71-9073

Reference: OH-142 Safety Analysis Report, Docket No. 71-9073

revised pages to
the OH-142 SAR

MODEL OH-142 SHIPPING CONTAINER

B	H	OF 3
			DWG NO.	AL-20-202	
			SIZE

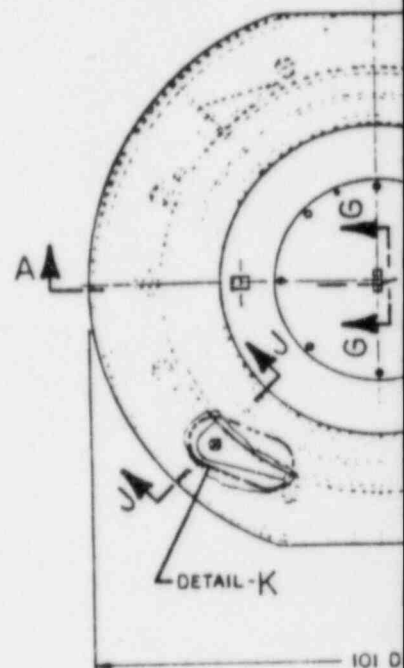
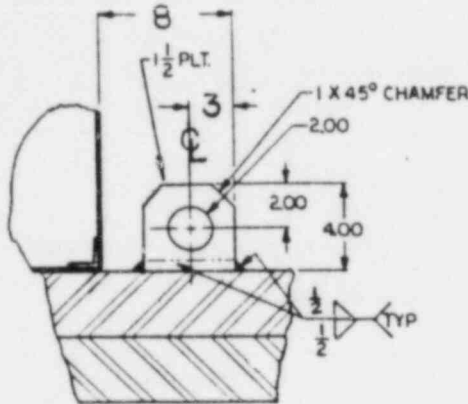
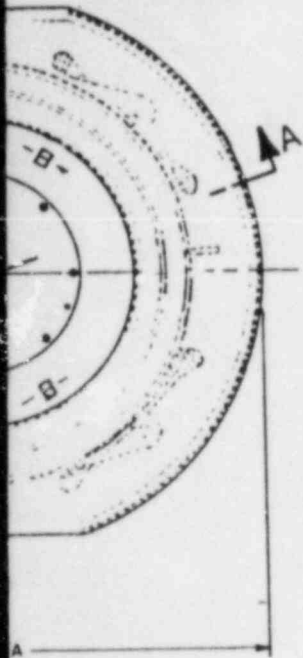
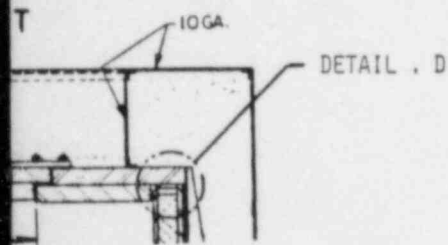
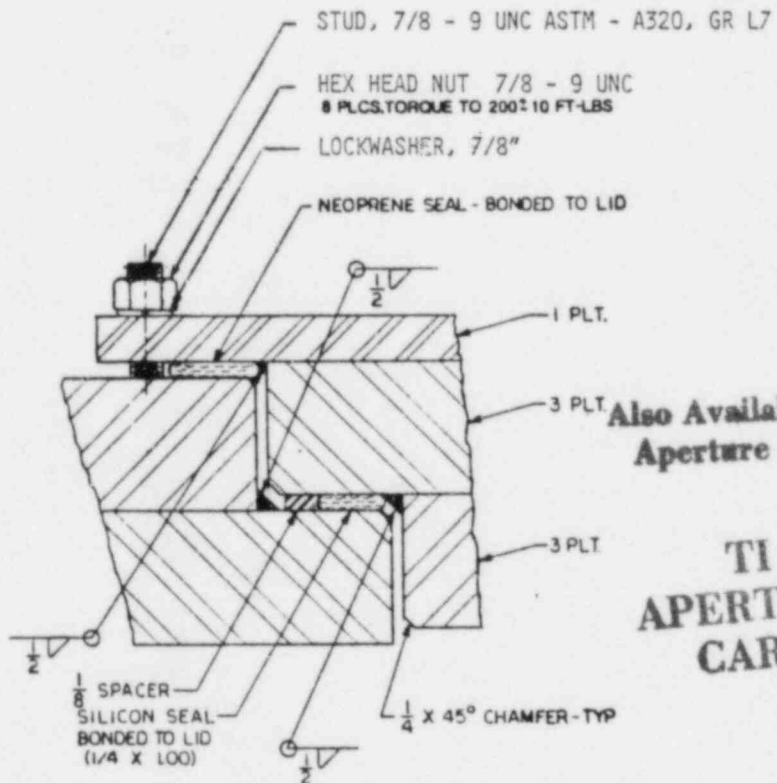
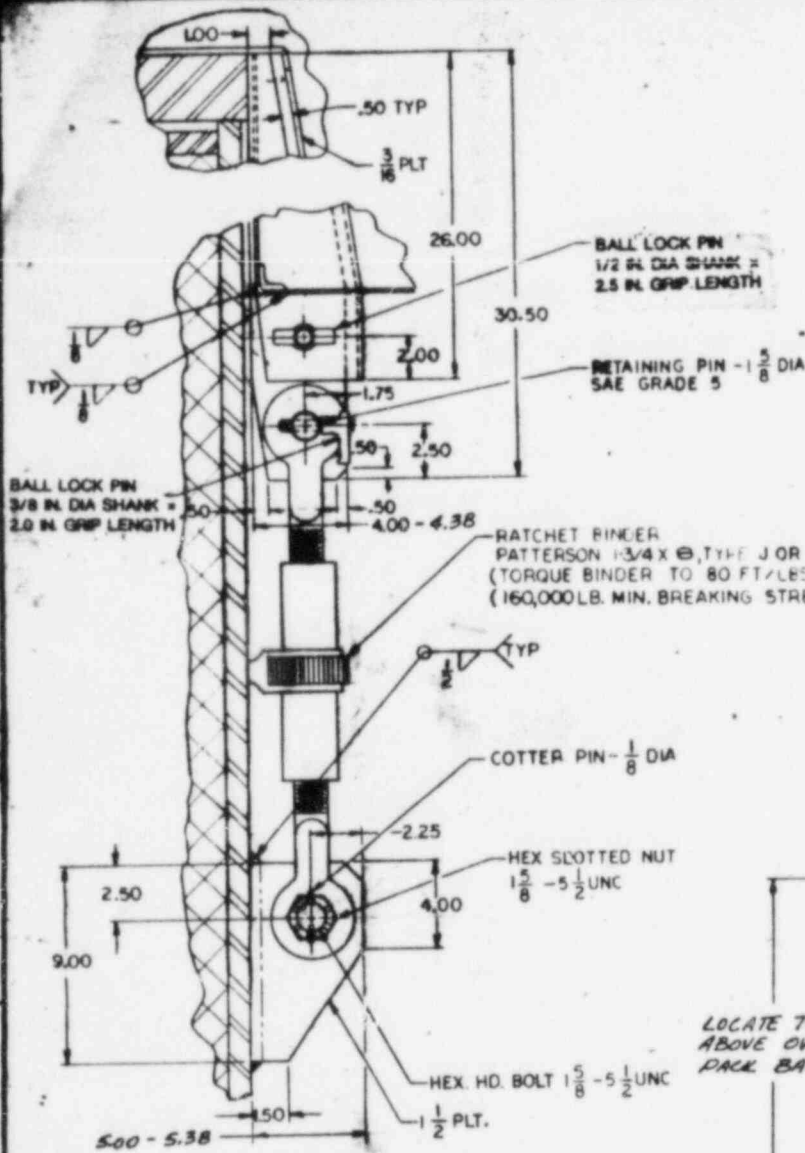
The thermal shield tolerance on the drawings has been changed to reflect a more realistic fabrication tolerance. Calculations demonstrating that the new tolerance has no effect on the package's ability to meet the requirements of 10 CFR 71 is included as Attachment I to this letter.

14. NOMINAL AIR GAP (MINIMUM .05, MAXIMUM .42 IN.)

AL-20-203

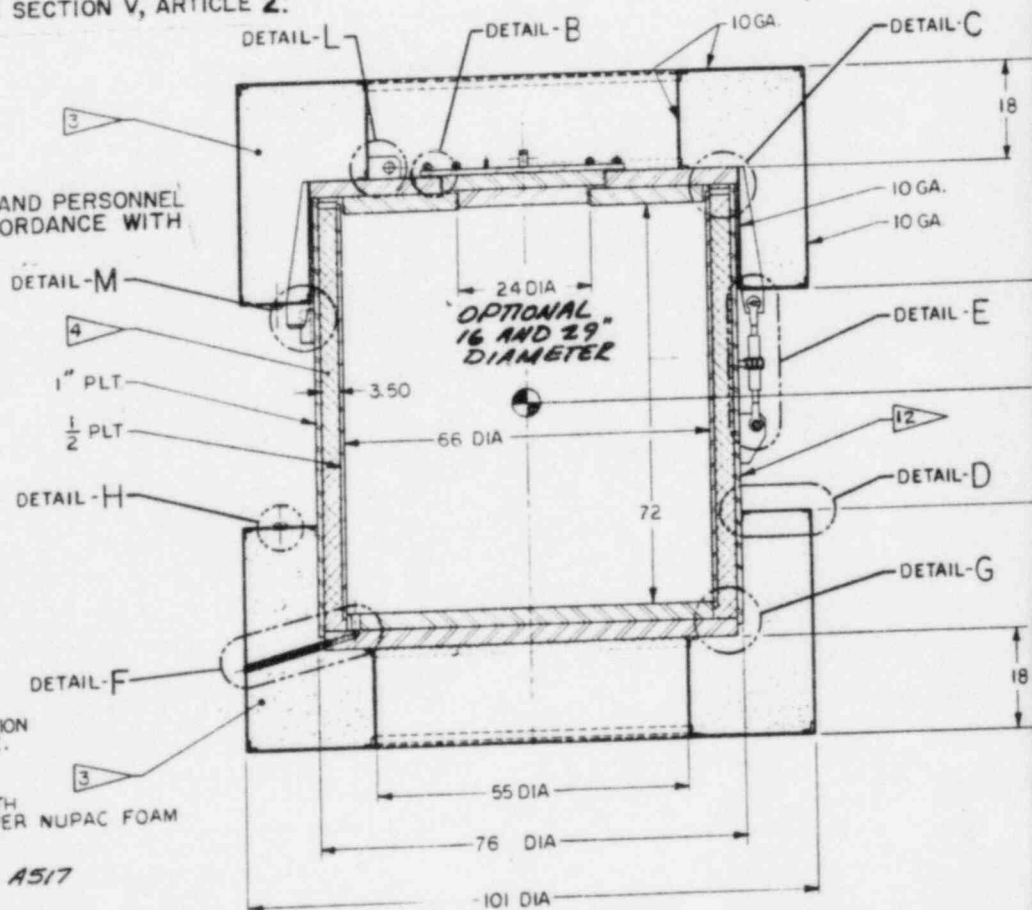
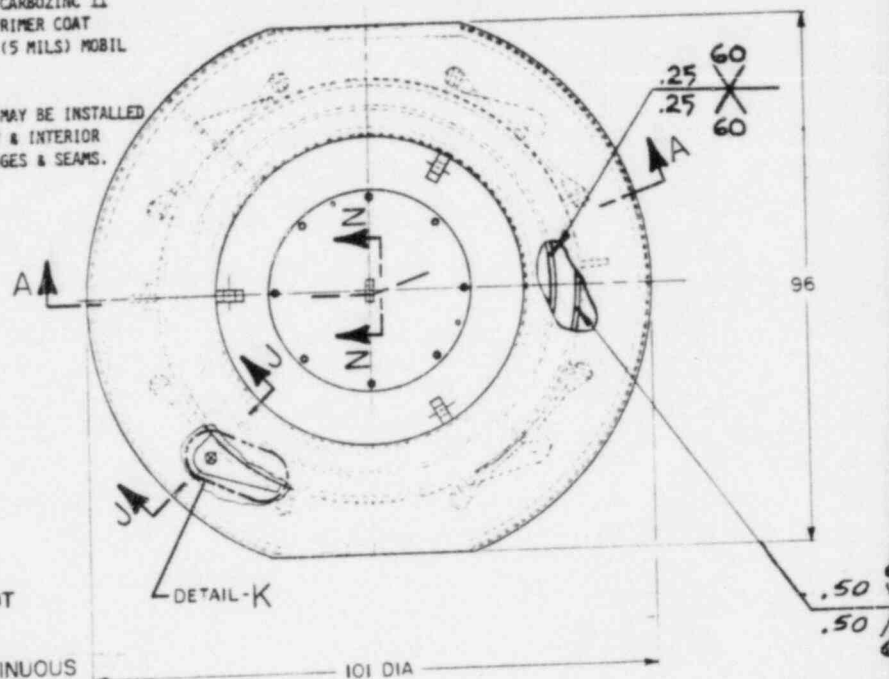
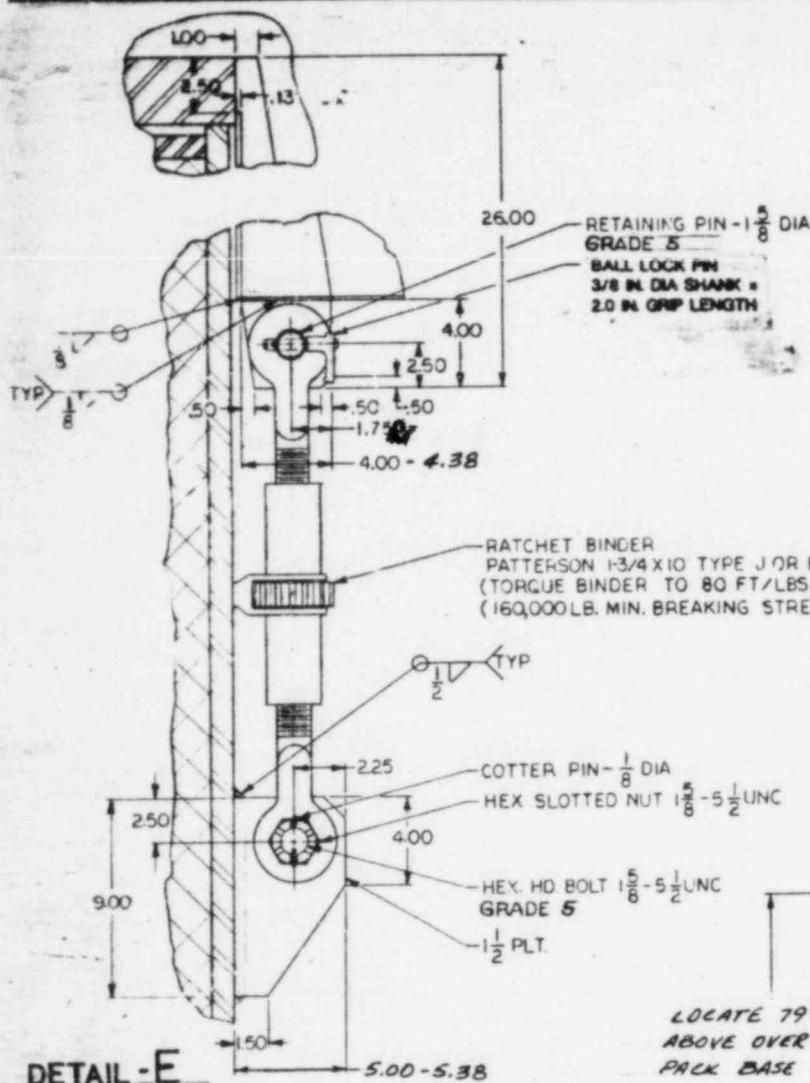
13. NOMINAL AIR GAP (

Y-20-2020

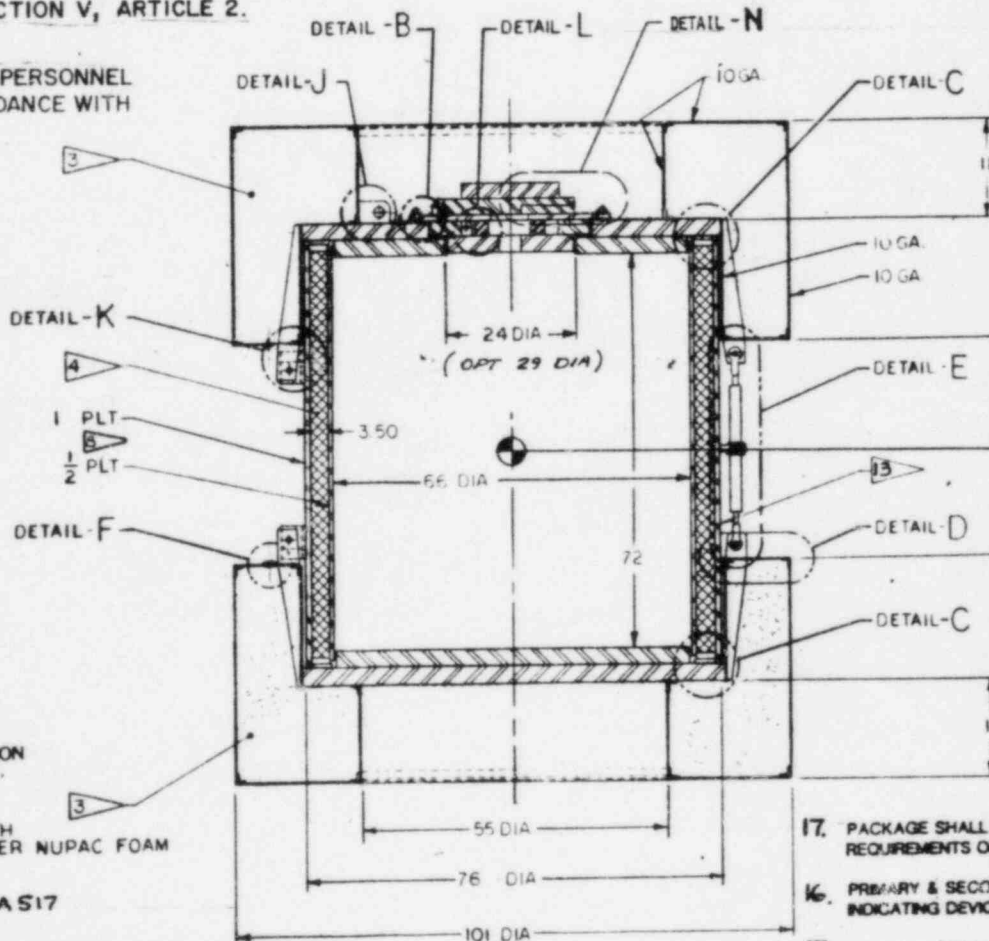
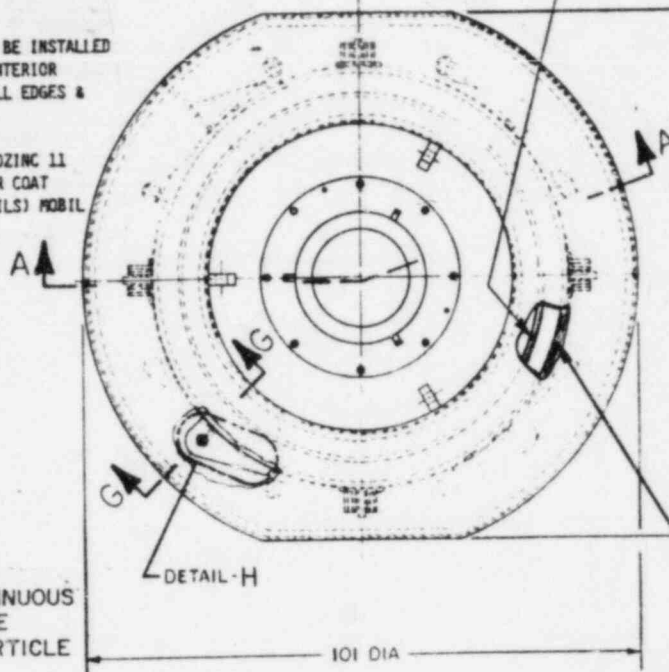
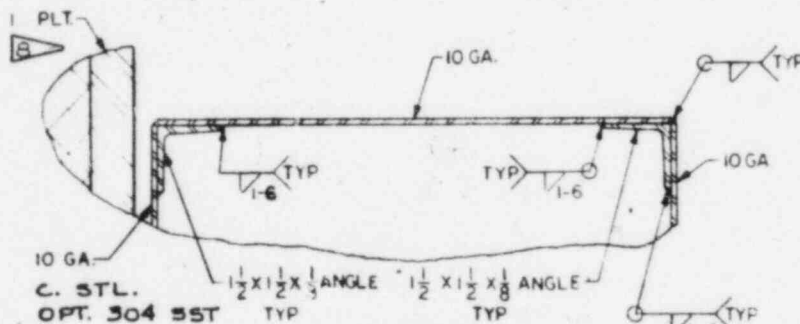
14 NOMINAL AIR GAP (MINIMUM .05, MAXIMUM .42 in.)
